**California Audubon Society
dba San Fernando Valley Audubon Society (SFVAS)
Comments on September 2006 draft Sepulveda Dam Master Plan
October 6, 2026**

Figure 3. Detail of misclassified area approximately 11 acres.

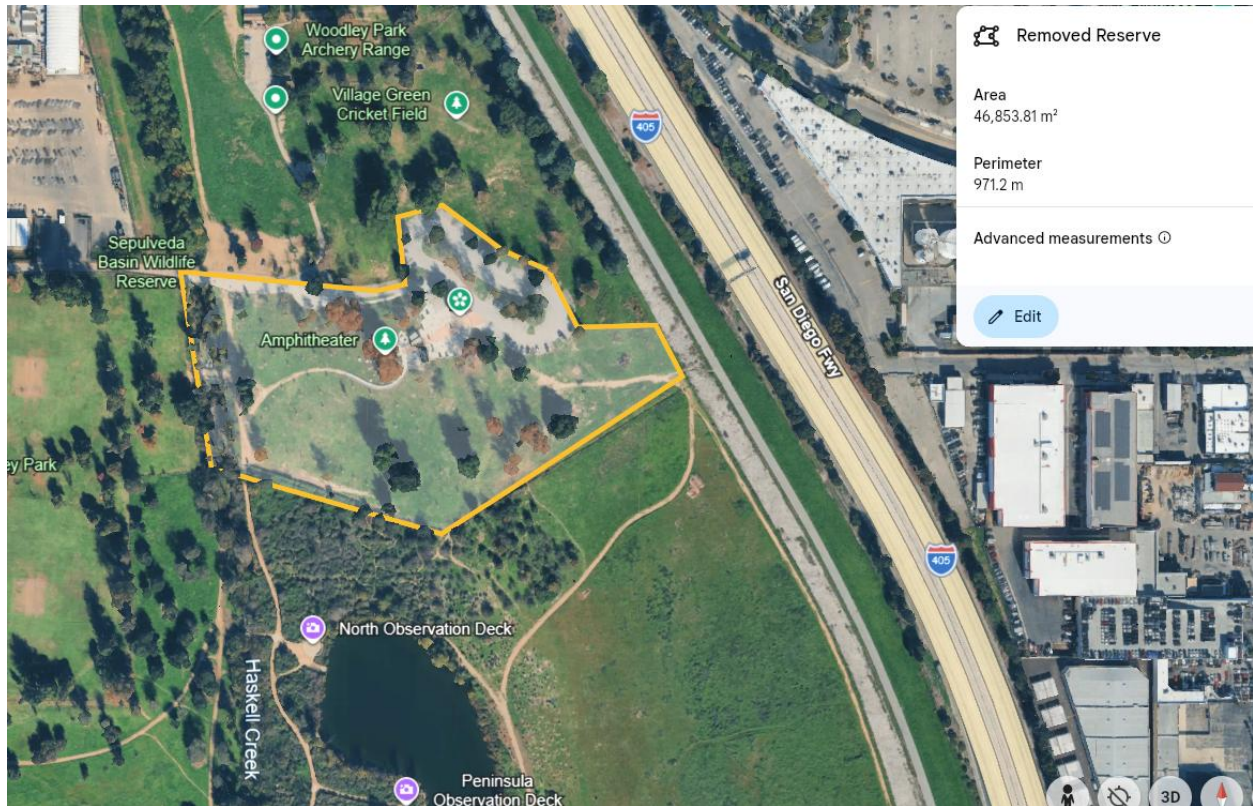
A critical error in the draft plan has been made in reclassifying a portion of the SBWR formerly-ESA land to High Density Recreation rather than to Wildlife Management. Details follow.

SFVAS was instrumental in the design of the SBWR and has continuously led educational, preservation and habitat restoration efforts individually and in collaboration with the Sepulveda Basin Wildlife Areas Steering Committee. It is indeed a significant urban bird sanctuary and as such requires that it be protected. The 2011 Sepulveda Dam Master Plan classified the entire SBWR as ESA - see Figure 1. Most of the SBWR that was classed as ESA in the 2011 Plan is now classed as Wildlife Management (WM). We strongly object to one significant exception. A 12 acre portion of the SBWR, including the riparian tract along Haskell Creek south of Wildlife Way has been reclassified to High Density Recreation. The illustrations at the end of these comments show the location.

This reclassification is totally inappropriate and SFVAS strongly requests that it be changed to Wildlife Management:

That area has been considered part of the SBWR since 1988, when the Wildlife Reserve was expanded to include this area and the area between Haskell Creek and Woodley Avenue, and the restroom and storage buildings and small amphitheater were built, with a parking lot with plantings of native trees to serve them. Included in the project were new pedestrian bridges across Haskell Creek and improved viewing areas and pathways. Haskell creek was improved and more native plantings and informational signs were added.

1. The excluded area of Haskell Creek contains riparian habitat with many nesting birds including Least Bell's Vireos.
2. The buildings, amphitheater, and lot were built to support maintenance and operation of the wildlife reserve and to enhance educational programs there.
3. Page 5-24 of the Plan states: "The wildlife area covers an area of 130 acres located in the northeastern portion of the SFCB..." If the erroneously reclassified area is not reclassified correctly, nearly 12 acres of that area are excluded from Wildlife Management in the SBWR.
4. Page 5-24 also states: "The [wildlife] area also has an educational staging area and amphitheater, pathways with signage and viewing areas, and Haskell Creek has been reconfigured and re-vegetated" as referred to in item 2.

To protect wildlife, the excluded area should not be used for any recreational activities other than quiet enjoyment - no bouncy houses, loud music, huge parties, fires, bright lights, etc. as in the entire SBWR.
